Addendum No. 1
November 10, 2021

Project: Corsica-Stickney H.S. Addition
Corsica, South Dakota
Architect's Project No.: 2910

Architect: Architecture Incorporated

SHEET INDEX

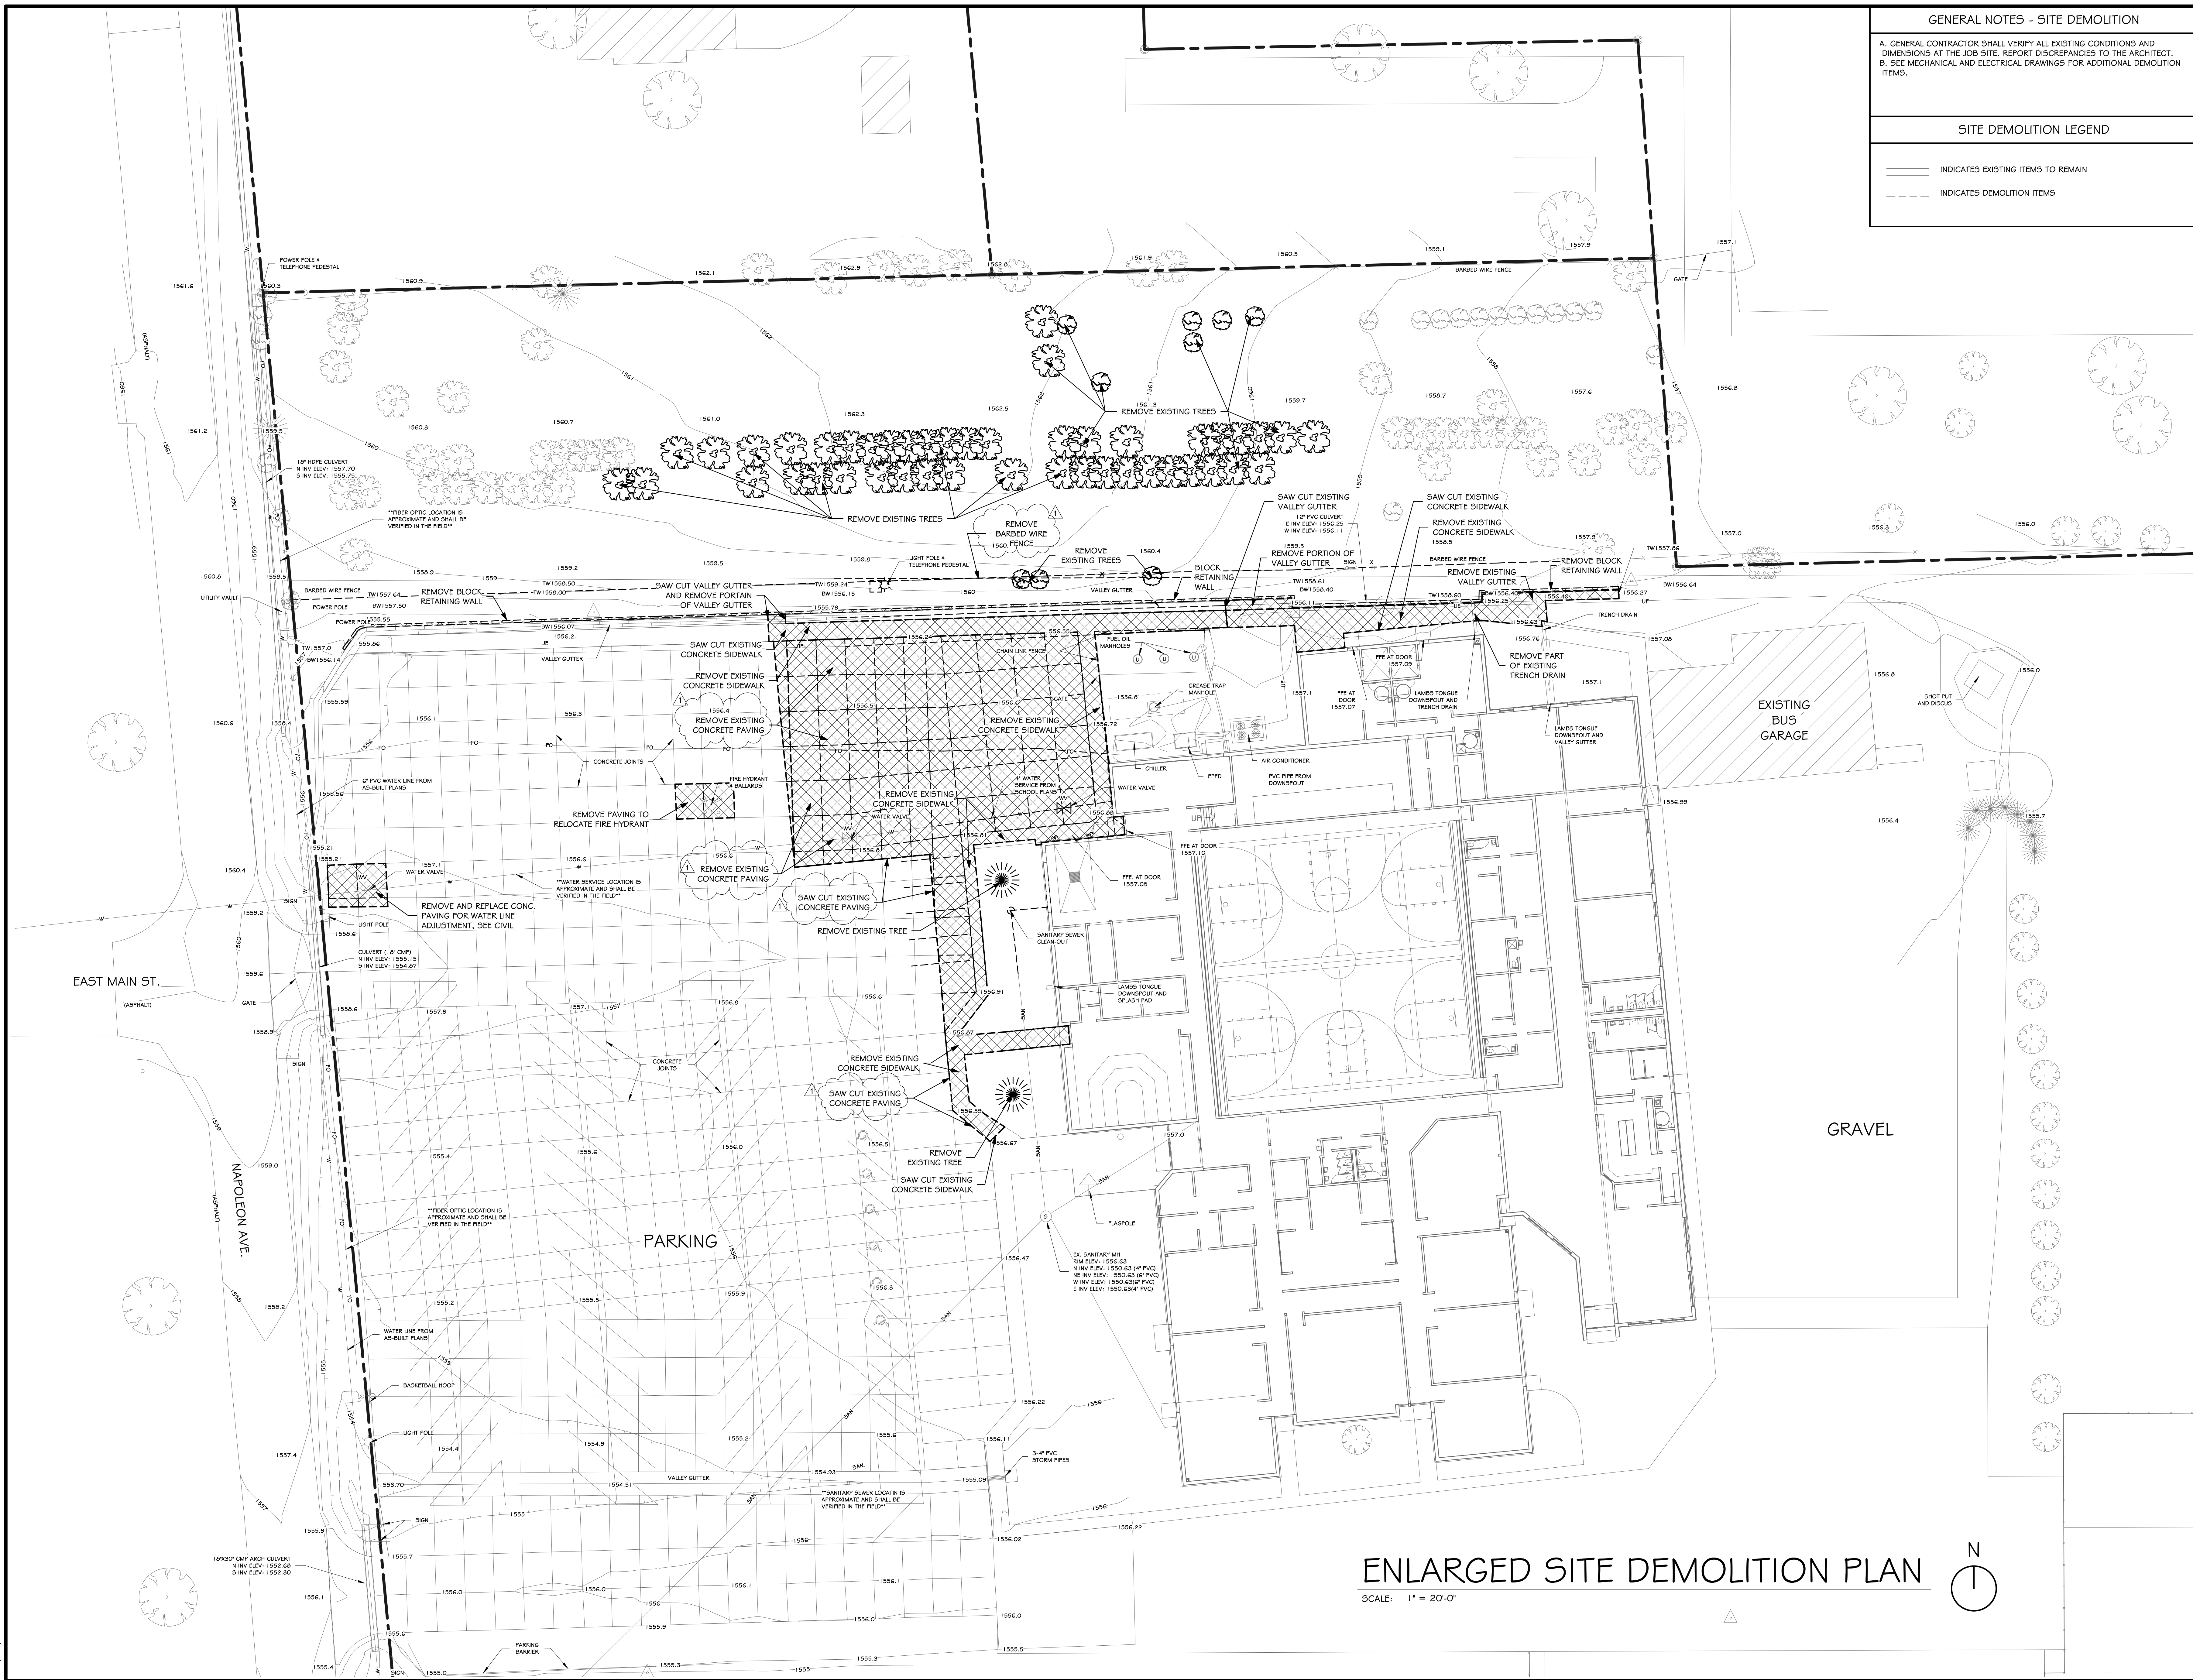
- a) Add entire Section. See attached section at the end of Addendum.
- 6) SHEET 0.0 TITLESHEET: See new sheet clouded and tagged with “1”
 - a) **MODIFY** the Electrical Sheet index
- 7) SHEET 2.20 ENLARGED SITE DEMOLITION PLAN: See new sheet clouded and tagged with “1”
 - a) **MODIFY** paving to be demolished to “concrete”
 - b) **ADD** The removal of the barbed wire fence
- 8) SHEET 4.00 DEMOLITION FLOOR PLAN: See new sheet clouded and tagged with “1”
 - a) **ADD** The removal and reinstallation note of existing signage
- 9) SHEET 4.40 ENLARGED FLOOR PLAN & MOUNTING HEIGHTS: See new sheet clouded and tagged with “1”
 - a) Detail 3|4.40 – **MODIFY** location of sanitary napkin dispenser
- 10) SHEET 4.51 INTERIOR ELEVATIONS: See new sheet clouded and tagged with “1”
 - a) **REMOVE** the lettering on the bleachers
 - b) **MODIFY** the number of tiers of bleachers to match specifications
